In the Matter of)
)
COMMONWEALTH EDISON COMPANY) Docket Nos. 50-237
) 50-249
(Dresden Nuclear Power Station,)
Units 2 and 3))

ORDER FOR MODIFICATION OF LICENSE

DRESDEN UNITS 2 AND 3 OPERATION RESTRICTIONS

FIGURE 3 5 1

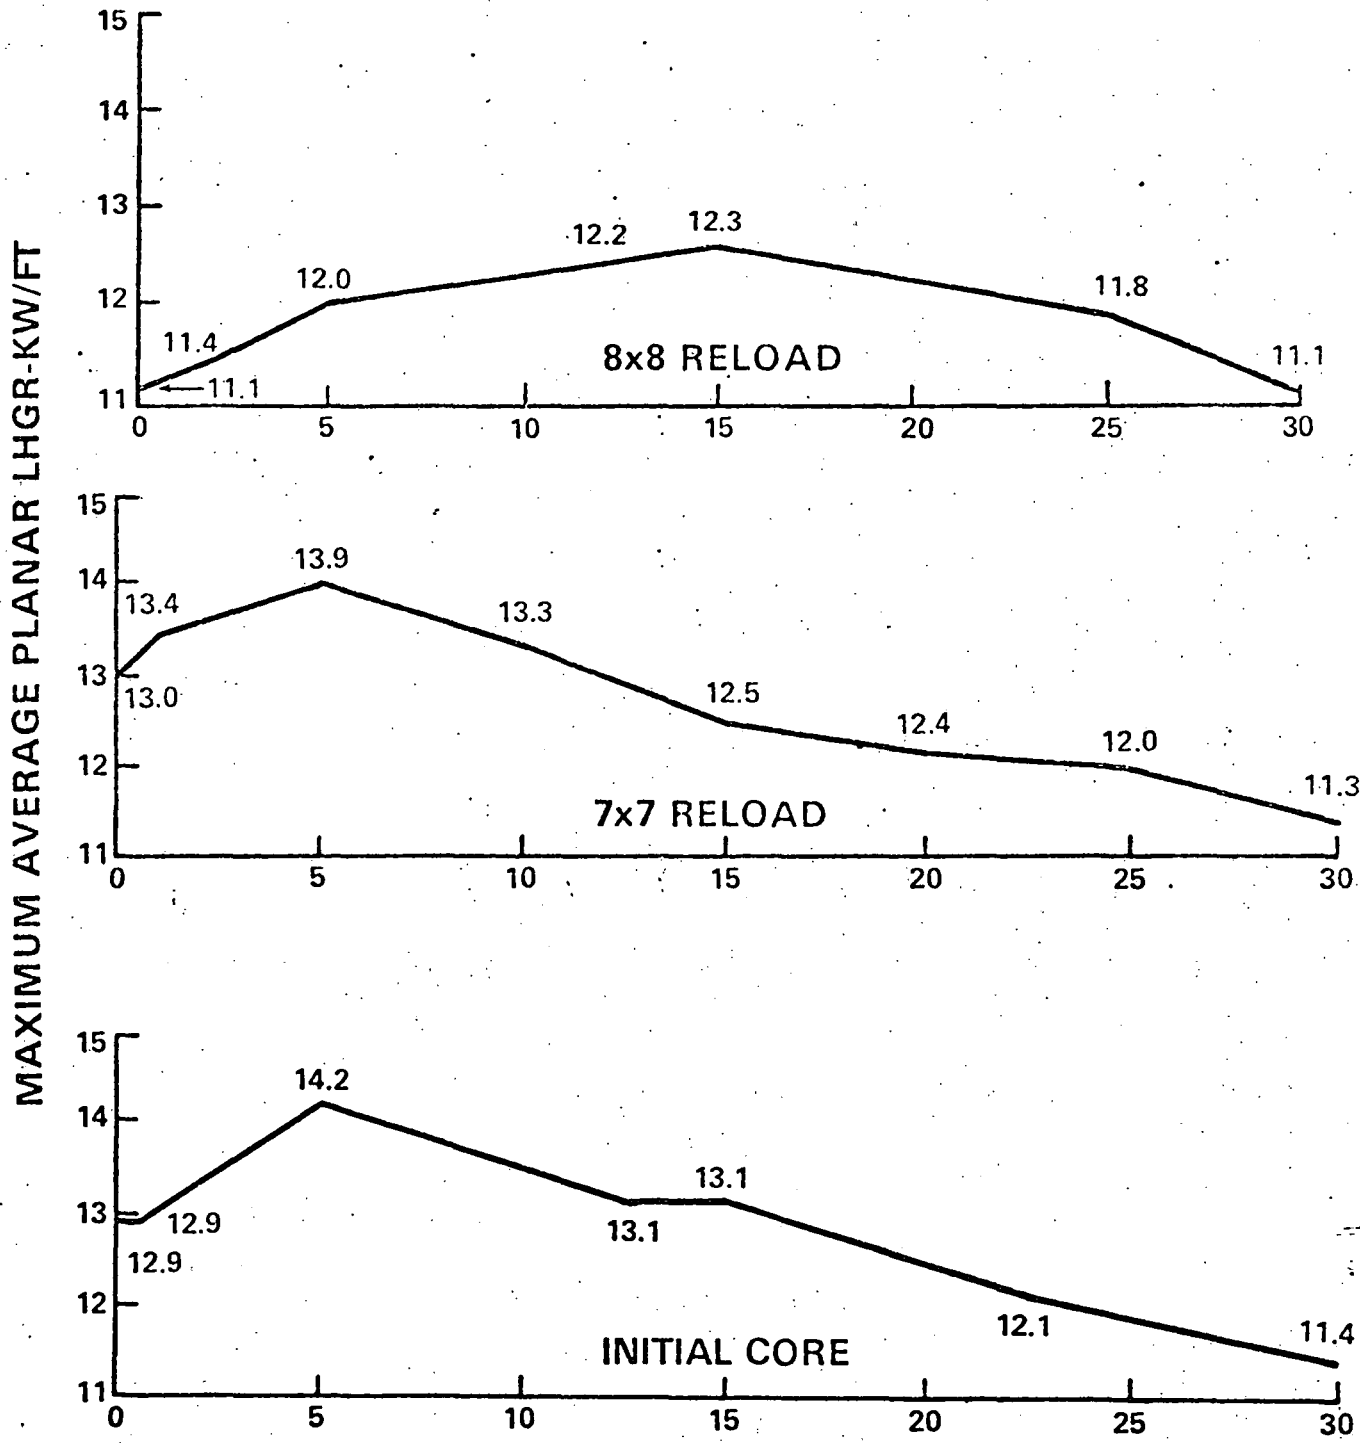
The proposed Technical Specification limiting conditions of operation present two limitations on power distribution related to the LOCA analysis. These are the limiting assembly maximum average planar linear heat generation rate, MAPLHGR, and the minimum critical power ratio limit related to boiling crisis, MCPR. The MCPR value used in the LOCA analysis was 1.19. The limiting value of MAPLHGR included with the proposed Technical Specifications submitted on August 5, 1974, have been revised to account for the General Electric ECCS Evaluation Model deficiencies which have been discussed in this report. The revised values are given in Figures B.3.11-1A and B.3.11-1B. Operation shall conform to these values. Operation shall also conform to a MCPR value of 1.20.
